**Appendix C-1**  
**Recommendations Memo, Chattel Historic Preservation Consultants**

## MEMORANDUM

**RE** San Marino Center (San Marino Women's Club)  
1800 Huntington Drive, San Marino, California  
Recommendations Memorandum

**NORTH ELEVATION**

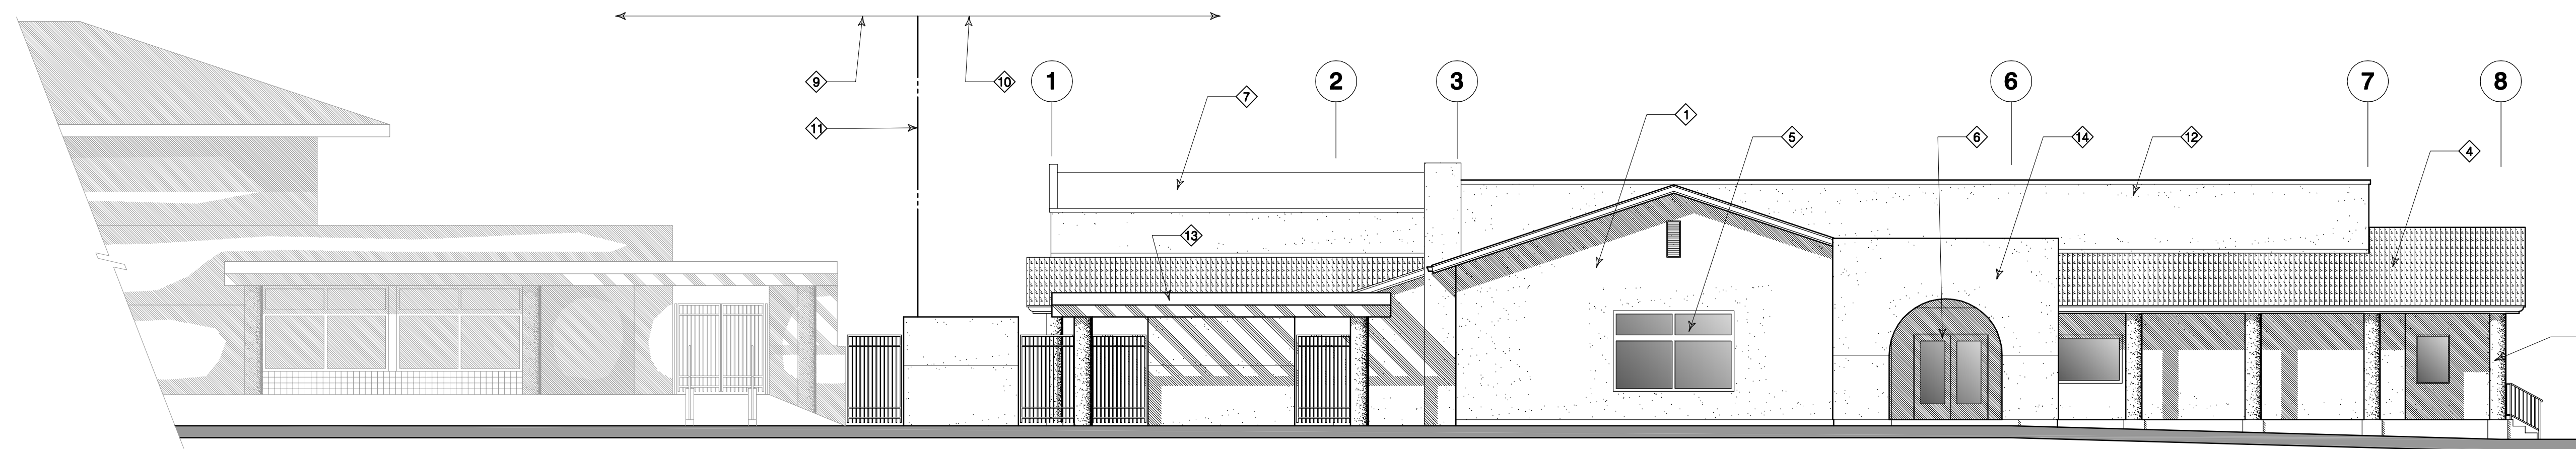
At the north elevation:

- Retain and rehabilitate character-defining features to greatest extent feasible.
- Retain wood shake roof or replace with compatible replacement such as red asphalt shingle or flat terracotta tile.

- Patch, repair and repaint stucco, as necessary. Stucco can be painted to be compatible with the library.
- Retain and rehabilitate square steel porch columns and ornamental ironwork, repaint as necessary. Columns and ornamental ironwork can be painted brown to be compatible with trim of the library.

- Rehabilitate and repair steel sash windows, as necessary.
- Retain and rehabilitate original paving, as necessary.
- Restore original planter at north elevation, match vegetation with library.

- Remove two porch additions (east storage addition and west office addition). Ensure that brick chimney is not damaged in removal of east storage addition. Chemically remove overpaint on brick.

- Detail wall and shade canopy to not touch existing building ensuring reversibility, and revise wall and shade canopy design to be subordinate to existing building. Provide only minimal metal infill at existing porch to enclose courtyard.

- Replace existing primary north entry door leaves to match existing.

**EAST ELEVATION**

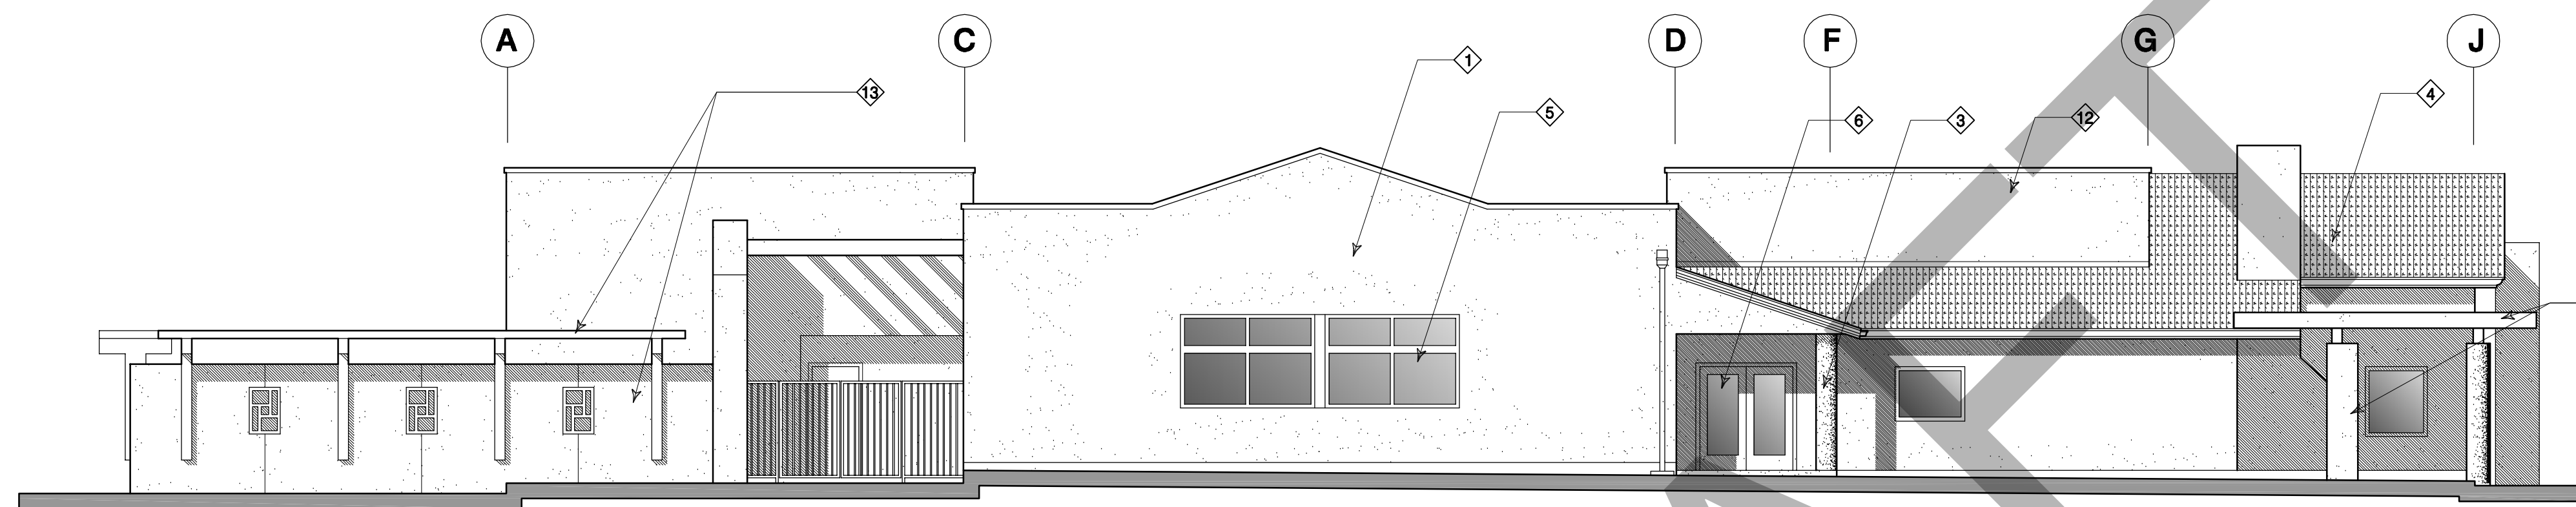
At the east elevation:

- Retain and rehabilitate character-defining features to greatest extent feasible.
- Patch, repair and repaint stucco, as necessary. Stucco can be painted to be compatible with the adjacent library.
- Rehabilitate and repair steel sash and wood grid windows, as necessary.
- Remove porch addition (east storage addition). Ensure that brick chimney is not damaged in removal of east storage addition. Chemically remove overpaint on brick. Restore steel sash doors that were removed to provide access into addition.

**SOUTH ELEVATION**

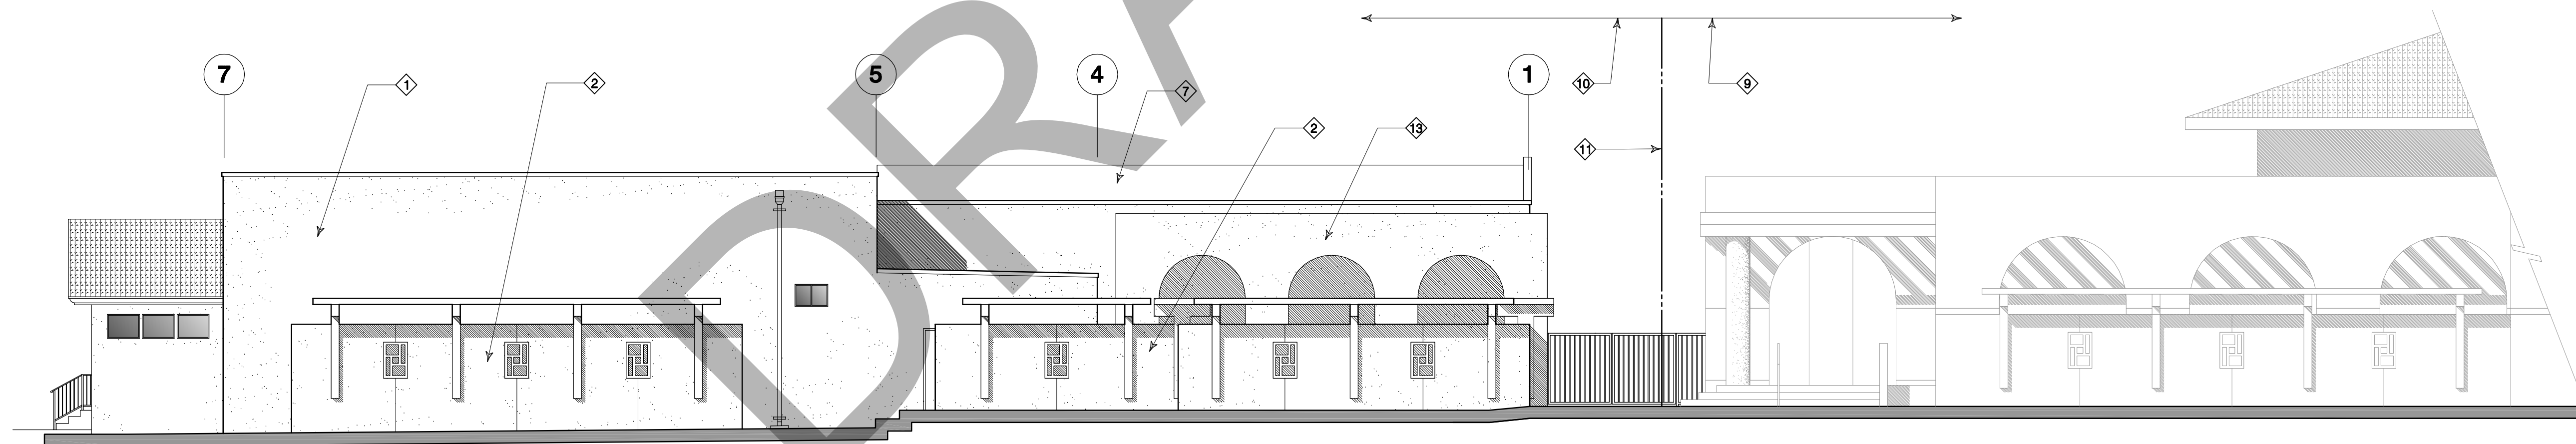
At the south elevation:

- Retain and rehabilitate character-defining features to greatest extent feasible.
- Patch, repair and repaint stucco, as necessary. Stucco can be painted to be compatible with the adjacent library.
- Rehabilitate and repair steel sash and wood grid windows, as necessary.
- Detail wall and shade canopy to not touch existing building ensuring reversibility. Simplify design of the screen wall and trellis to eliminate round arches and detail to be self-supporting and not attached to the existing building.

**WEST ELEVATION**

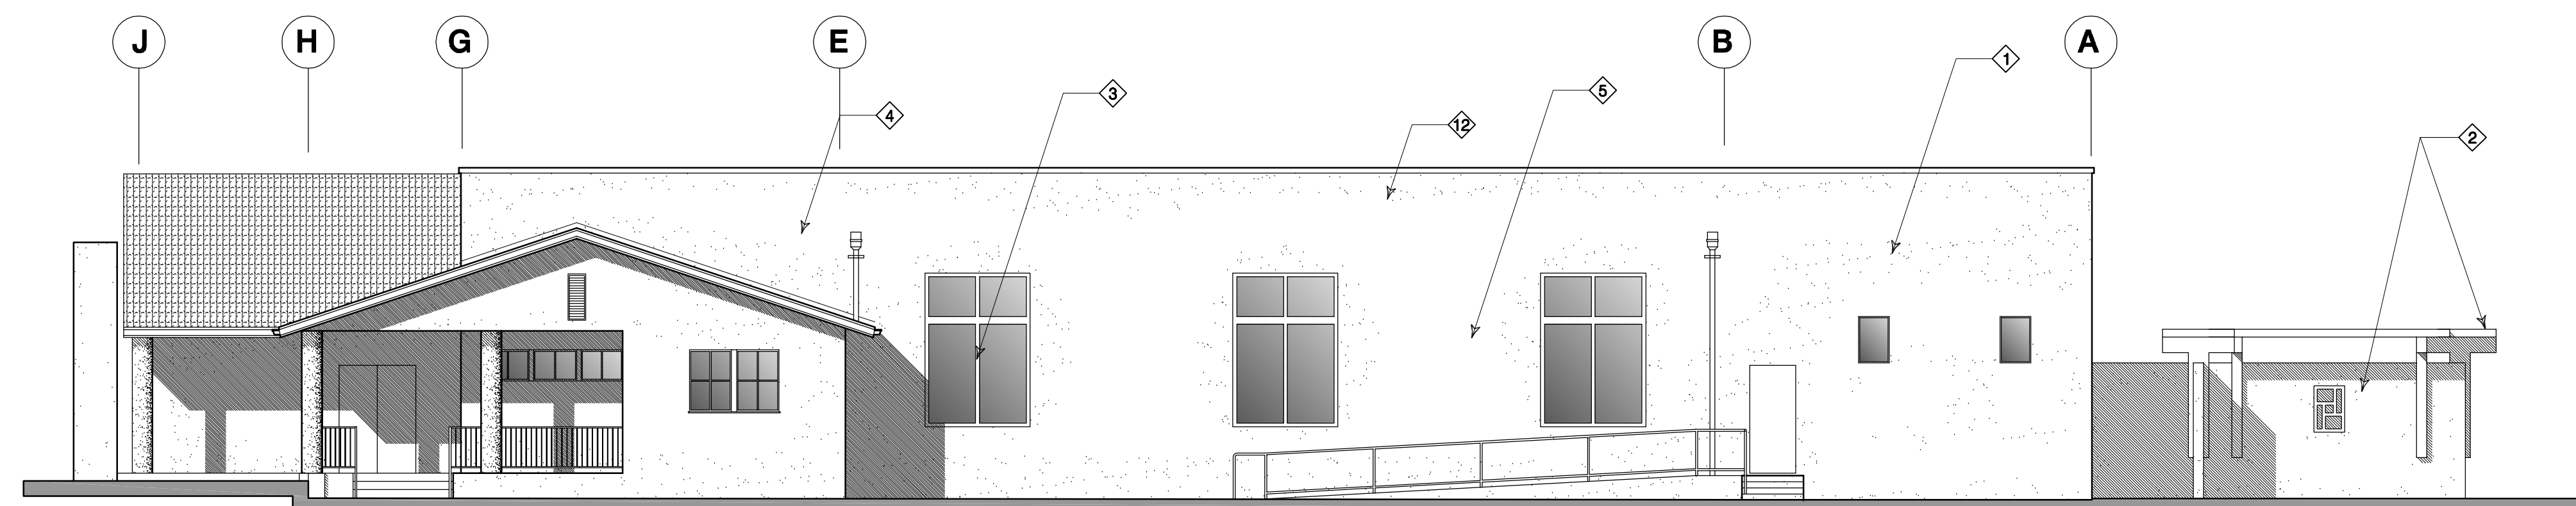
At the west elevation:

- Retain and rehabilitate character-defining features to greatest extent feasible.
- Patch, repair and repaint stucco, as necessary. Stucco can be painted to be compatible with the adjacent library.
- Rehabilitate and repair sheet metal window awnings, repaint as necessary.
- Rehabilitate and repair steel sash windows, as necessary.

- Remove porch addition (west office addition). Restore missing square steel porch columns with ornamental ironwork.
